LSD Gardner Food Service

Bid Pack 2, Addendum No. 1

Narrative of Changes

Project Name:	Gardner Elementary Food Service – Equipment Replacement & Renovations SO-1852	Date:	April 3, 2026
Project Location:	333 Dahlia Dr, Lansing, MI 48911	Architect's Project #:	26000752A
Owner/Client:	Lansing School District	Attention:	David Beckering
Issued to:	Beckering Construction	Email:	djb@beckering.com
City/State:	Grand Rapids, MI	Zip:	49548

CODE COMPLIANCE & LIFE SAFETY PLANS

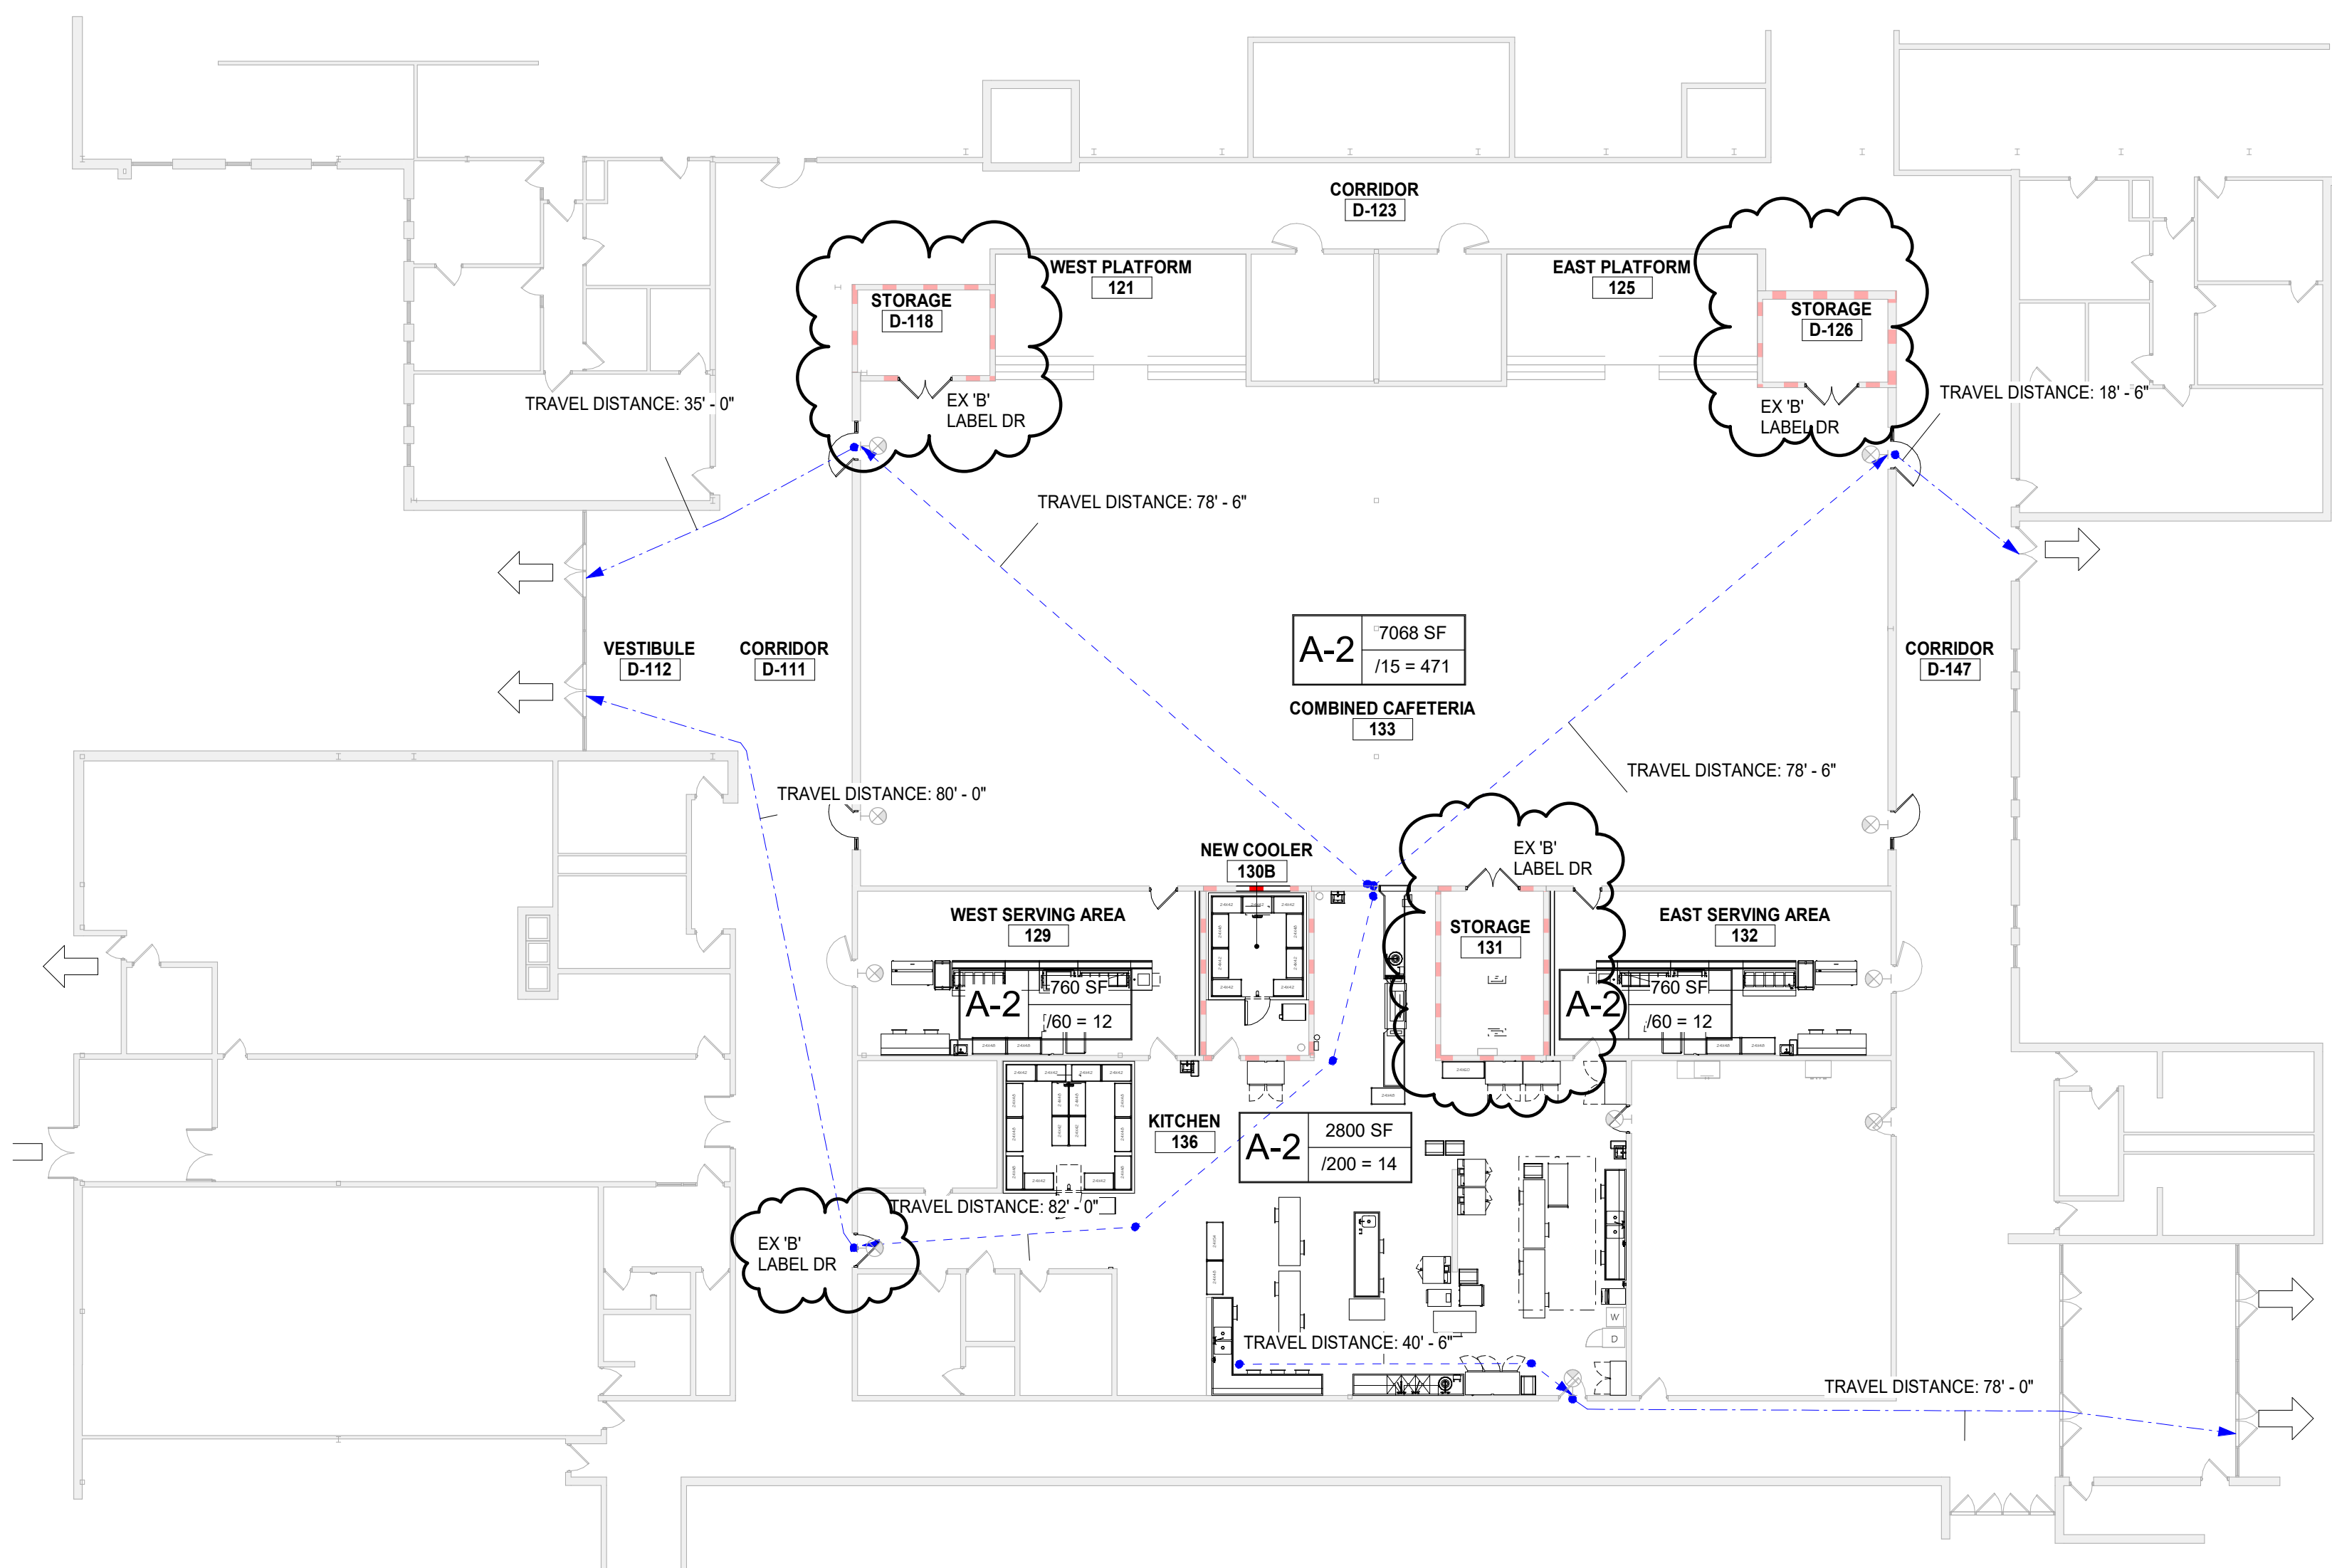
- G001 – CODE COMPLIANCE & LIFE SAFETY PLANS
 - Added notes about existing 'B' labeled rated doors
- A141 – FIRST FLOOR FINISH PLAN (Reissued)
 - Removed paint tag from bubbled door. All hm door frames and HM doors to get painted. Existing wood doors remain unpainted. New wood doors are factory finished. Doors not in the door schedule have been noted on sheet A141 as to what gets painted.

DETAILS, SYMBOL LEGENDS & SPECIFICATIONS

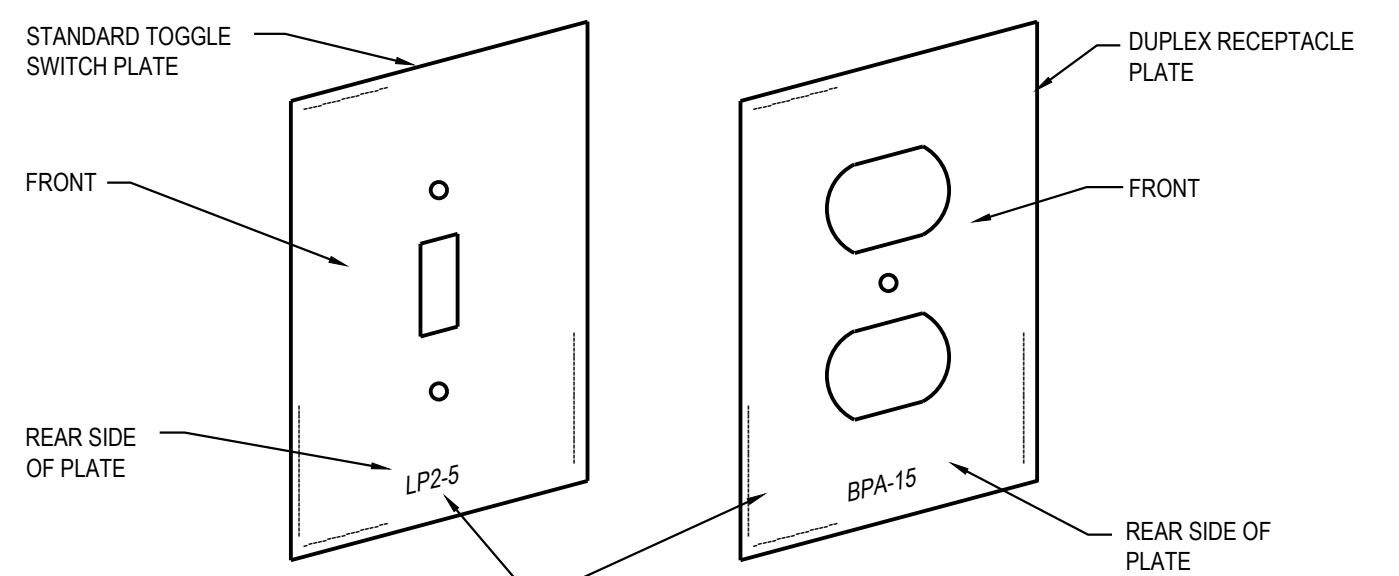
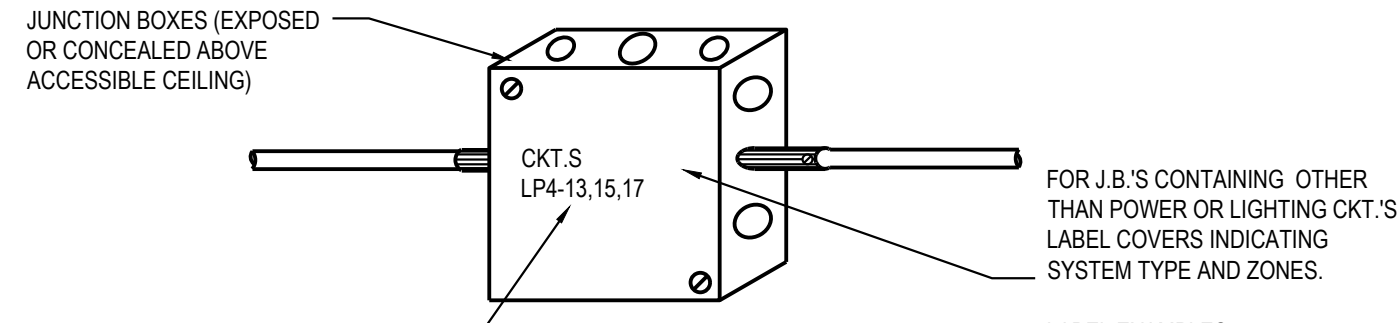
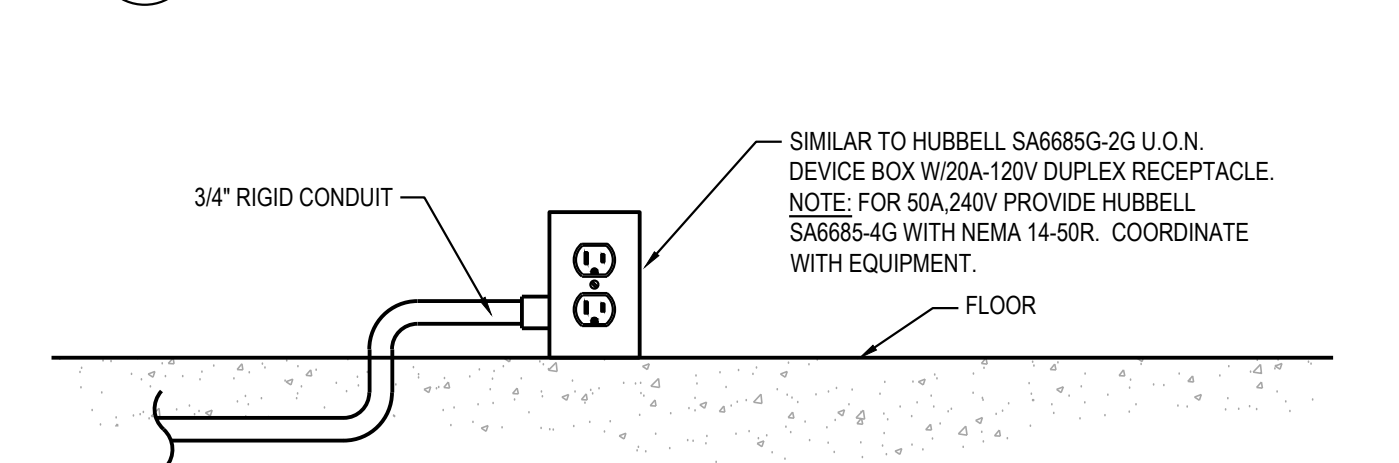
- E100 – DETAILS, SYMBOL LEGEND & SPECIFICATIONS (Reissued)
 - Changed type B to Lumenwerx 1500 Lumen per LF
 - Watt stopper is approved for lighting controls

- Williams, Columbia approved lighting manufactures
